**Addendum Number One**

To The Drawings and Specifications for  
**Red Brick (East and West) Restrooms at Lake Afton**  
**Bid # 24-0071, Sedgwick County, Kansas**

Issued: Wednesday, October 30, 2024

**HANNEY & ASSOCIATES ARCHITECTS**

MI.I  
 OF SHEETS

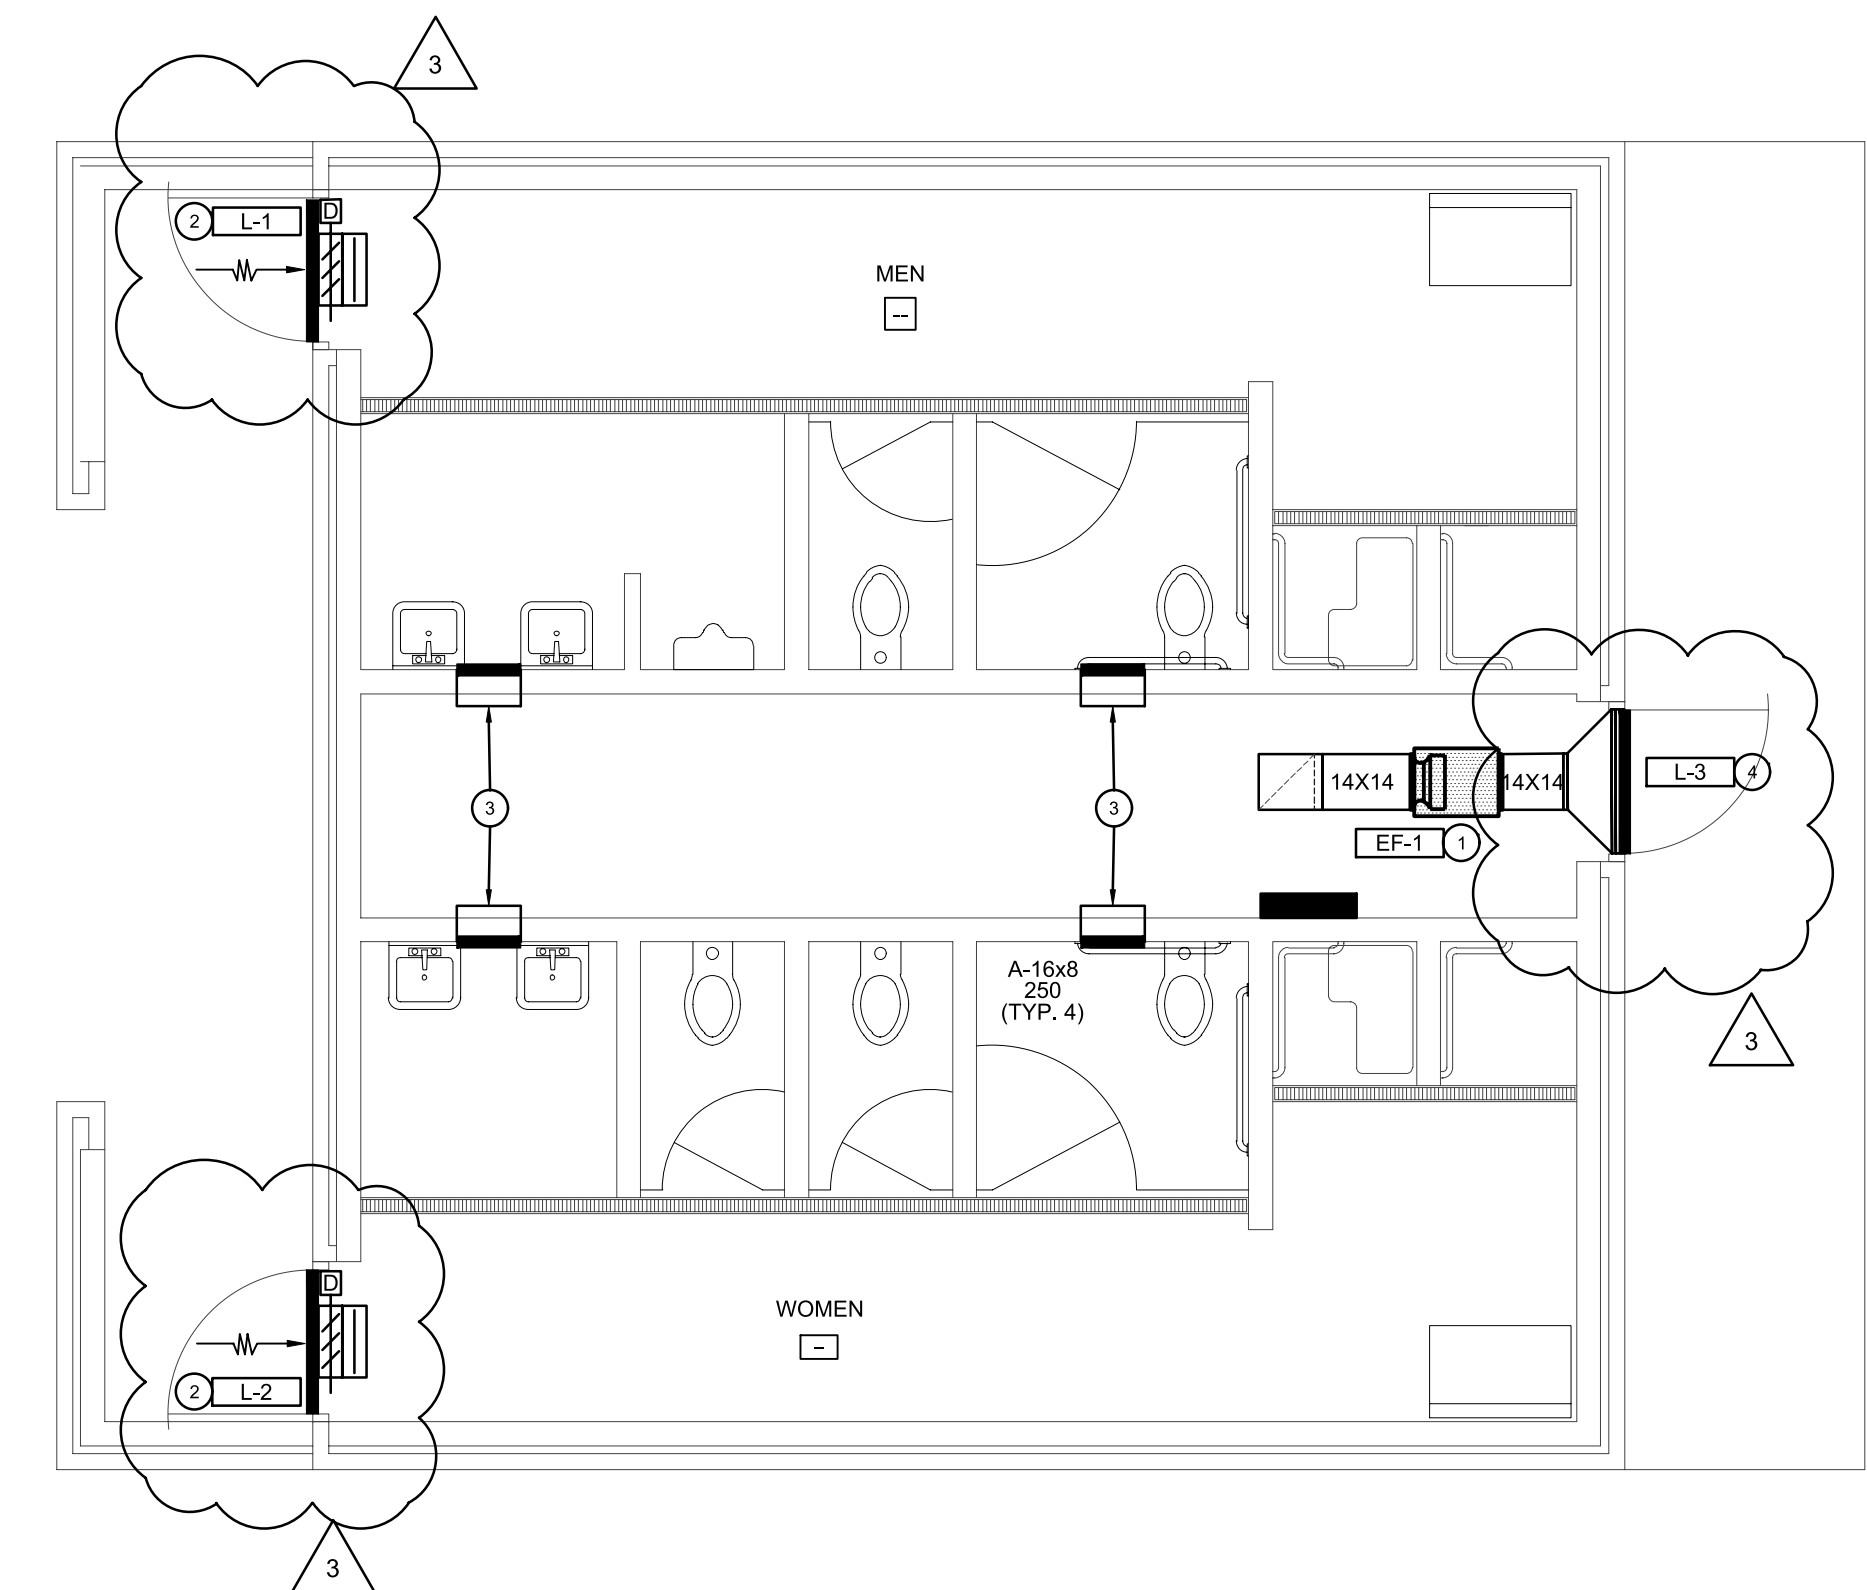
- 4.1 Sheet M1.1  
This sheet has been revised as noted below, and is reissued with this addendum.
- A. Resized the louvers to match those shown on the Arch sheets.
  - B. Notes 2 & 4 have been edited.
- 4.2 Sheet MP1.1  
This sheet has been revised as noted below, and is reissued with this addendum.
- A. Added a detail for the louvers.
  - B. Added a louver schedule.
  - C. Control of EF-1 shall be “continuous operation”.
